<b>Agenda #:</b>	4	<b>Status:</b>	ALUC-Regular-NW
<b>Type:</b>	ALUC-Document	<b>Department:</b>	Airport Land Use Commission
<b>File #:</b>	AC 24-009	<b>Contact:</b>	Nedzlene Ferrario
<b>Agenda date:</b>	03/14/2024	<b>Final Action:</b>	
<b>Title:</b>	ALUC-24-04 (Nut Tree Business Park)

Approve the lighting plans for the Nut Tree Business Park project located on the northside of Nut Tree Road (APN: 1029-240-500, 510, 520 and 530) as submitted subject to staff review and approval of the avigation easement to be recorded by the applicant

**A** ELECTRICAL PLAN - SITE LIGHTING - WEST  
SCALE: 1/32" = 1'-0"

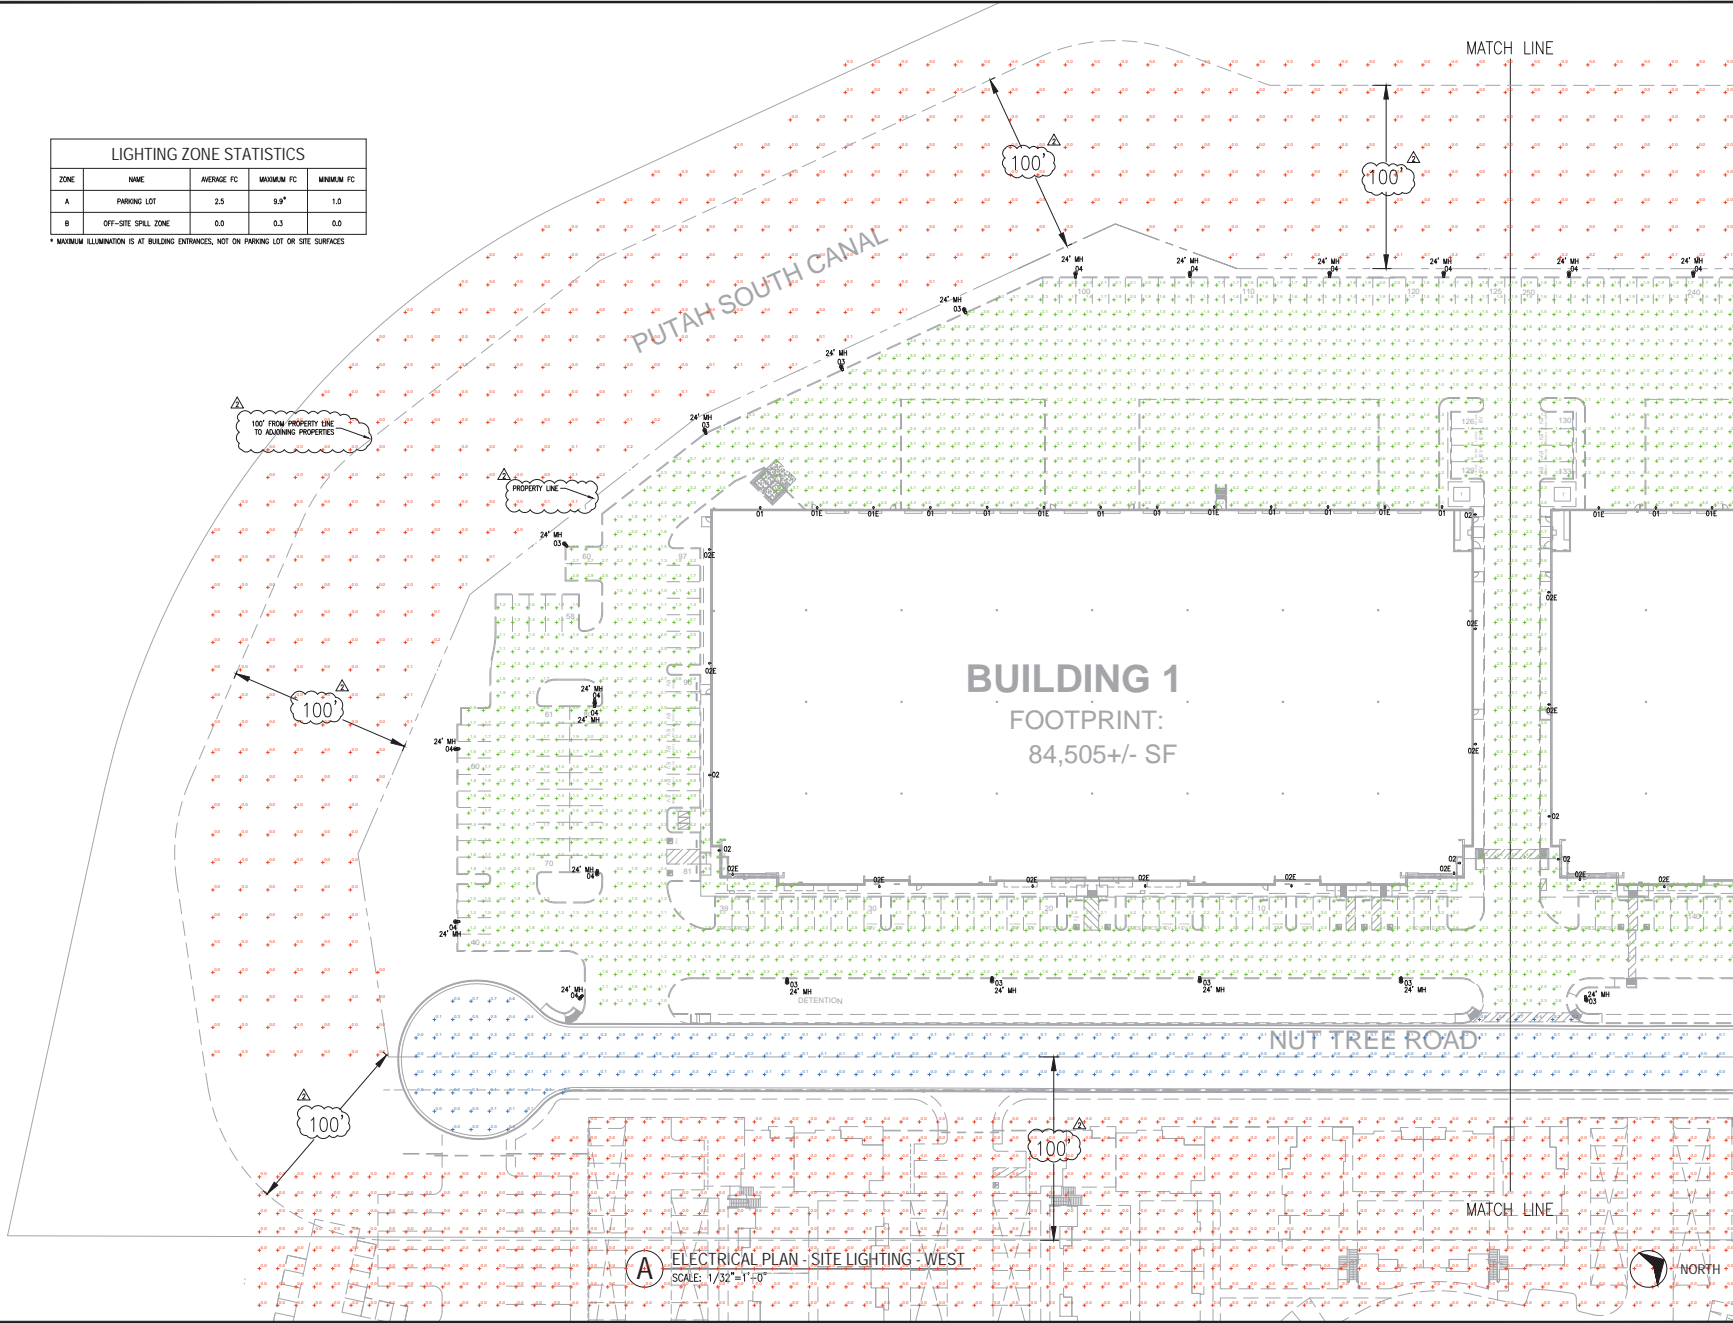
The proposed lighting fixtures are either attached to the building (wall pack) or pole lights 20-21 feet high and faced downward, located within the adjoining sidewalk to the building. The photometric plans indicate that lighting will not illuminate within 100 feet of the northern boundary line, closest to the runway, consistent with item B.

Regarding item C - City staff confirms that the proposed lighting plans meet City standards. Regarding FAA standards, email correspondence from Michael Meyers, FAA staff, indicates that there are no standards for lighting specifications of facilities off airport property; however, a Notice of Proposed Construction or Alteration under F.A.R. Part 77 may be filed if there may be a concern of glare interfering with pilot vision. Item D requires an avigation easement which restricts light and glare. Staff has not received the draft for review and recommends that ALUC condition the project to be subject to staff review and approval.

Staff recommends that the ALUC approve the lighting plans as submitted subject to the subject to staff review and approval of the avigation easement to be recorded by the applicant.
